4 February 2015

Re: SSD 14_6422 Teven Quarry Environmental Impact Statement (EIS)
Lots 1, 2 and 3 DP 732288, No.'s 129 – 181 Stokers Lane, Teven

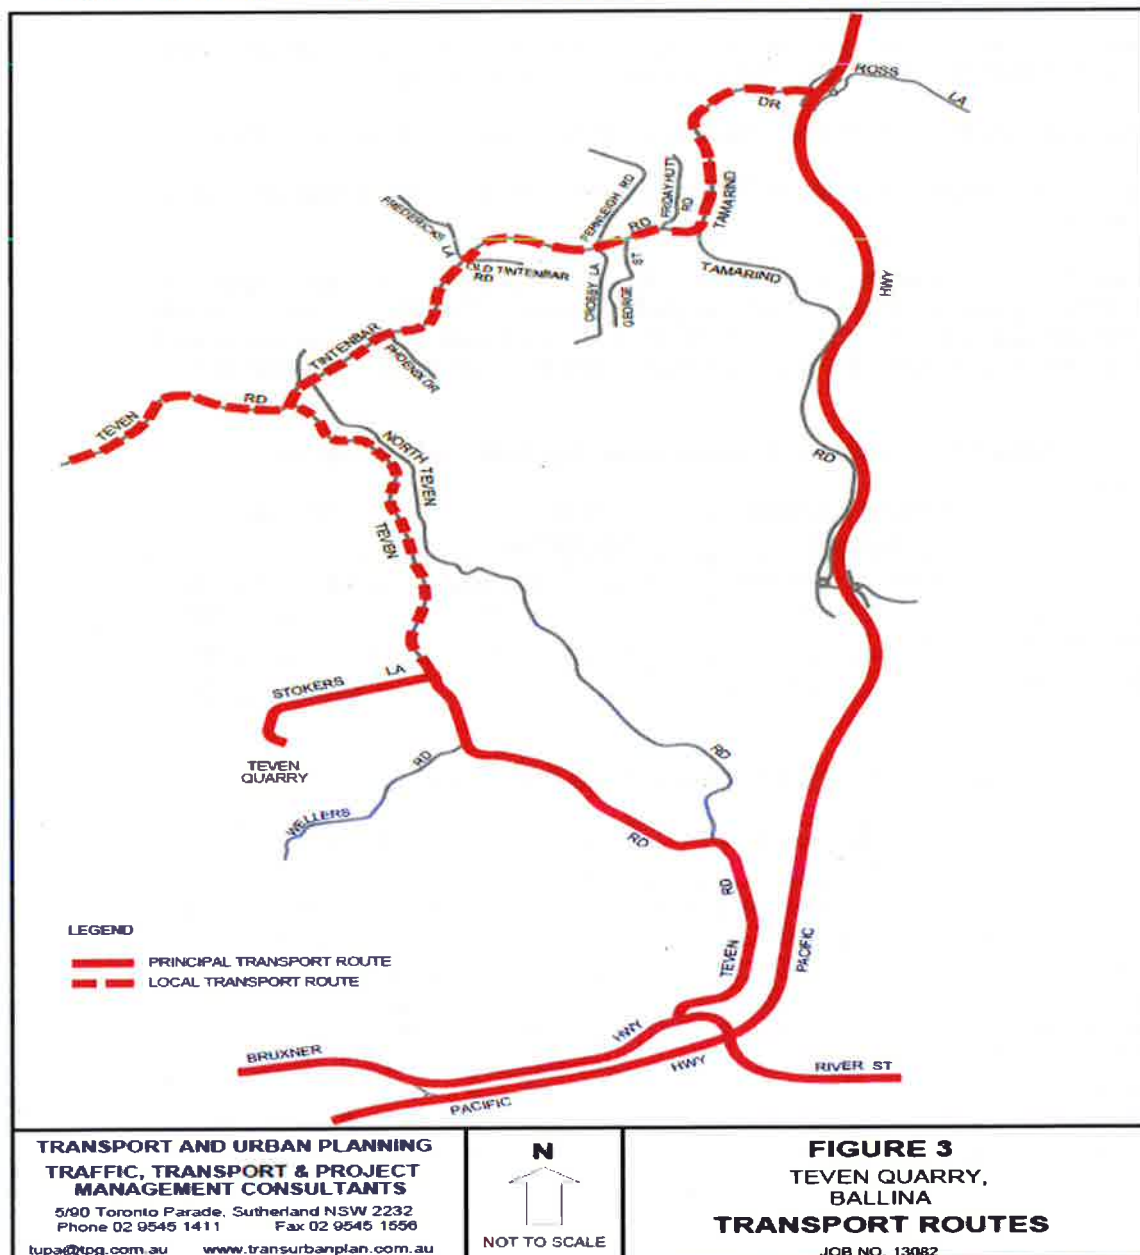
Of some concern is that Figure 3 shows Teven Road west of Tintenbar Road being a local transport route, but the submitted traffic volumes do not identify traffic (from the development) on this route. This matter is raised as the section of Teven Road, west of Tintenbar Road is steep and windy, has a poor accident record (including a recent head on fatality) and nearby residents report significant usage by Holcim delivery trucks, however impacts on this road are not addressed by either "Appendix 7 - Traffic Impact Assessment for Teven Quarry" and were not included in the scope "Appendix 8 - Road Safety Audit" Tintenbar Road east of Teven Road.

Further clarification should be requested for the market projections and delivery route assumptions that support the figures and route allocation apportionment provided by the proponent in EIS Appendix 7 including Tables 7.17, 7.18 and 7.19, an assessment of the current and projected traffic volumes on Teven Road west of Tintenbar Road and a revision of the scope of "Appendix 8 - Road Safety Audit" to include the section of Teven Road west of Tintenbar Road.
